ADDENDUM NO.2

**Richland-Bean Blossom C.S.C.
Edgewood Schools Projects - Playground**

This Addendum consists of Pages ADD 2-1, Pre-Bid Meeting Report, and Addendum 2 Drawing Sheets: C201, C301 & C501.

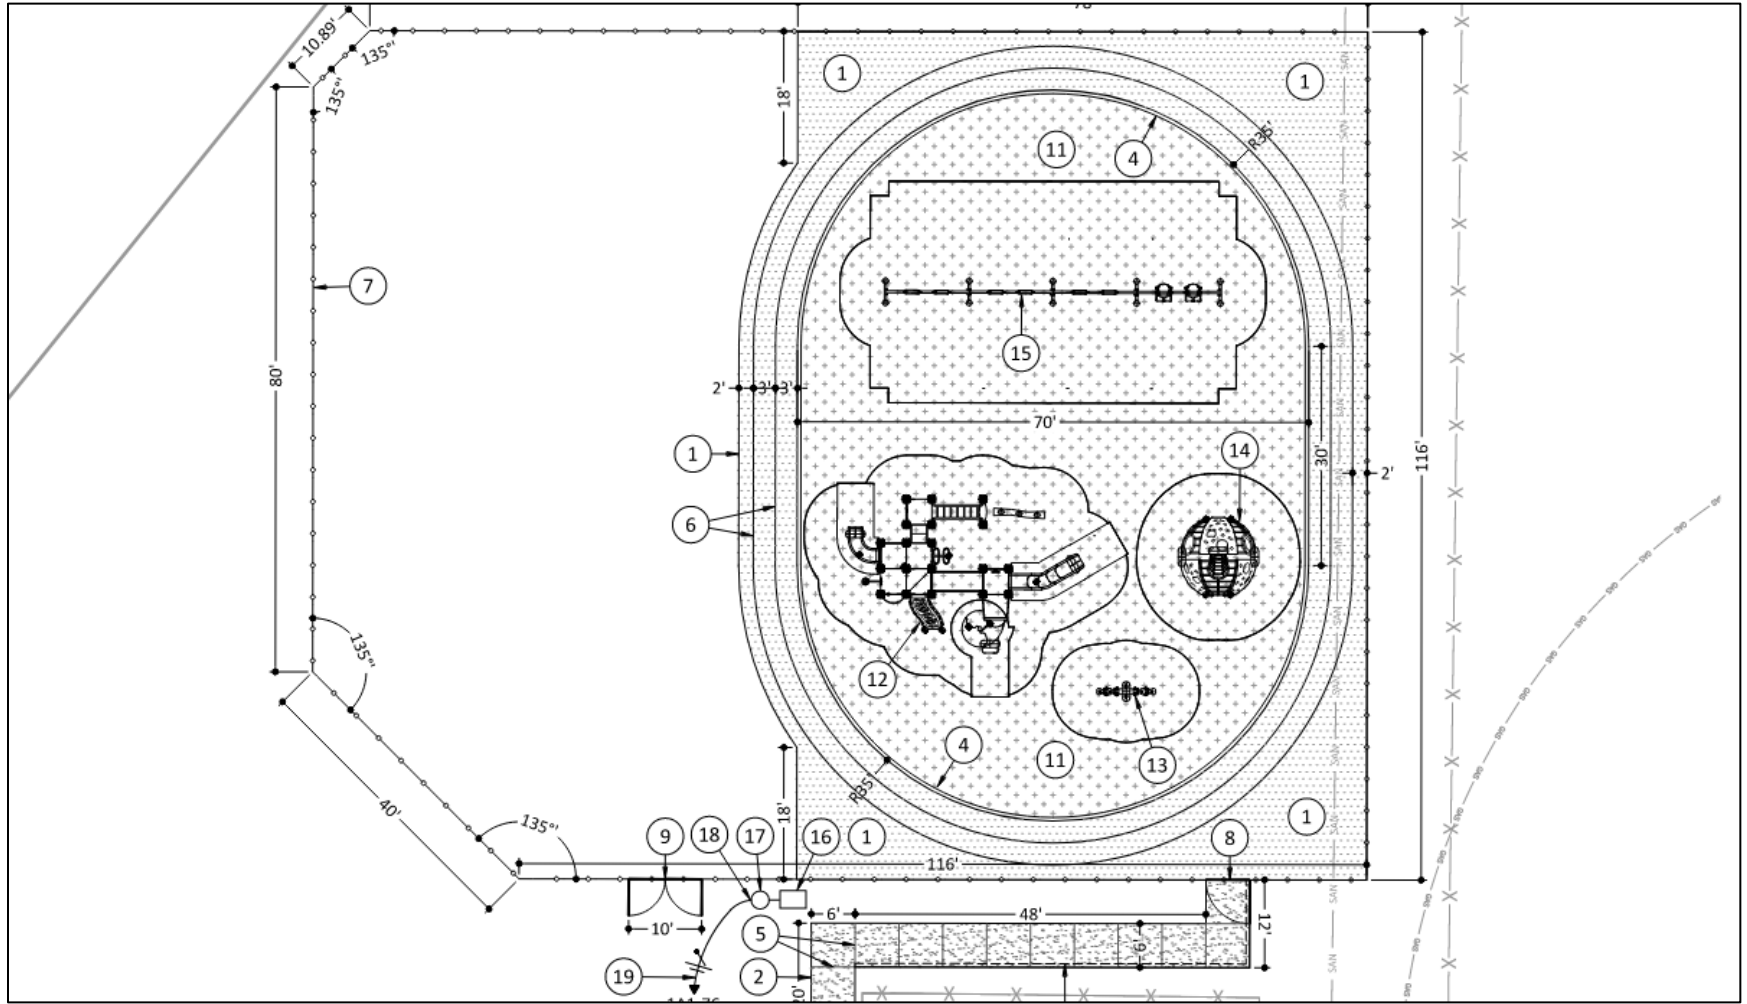
1. The area of Playground Soft Surfacing is 5,809.28 sf.
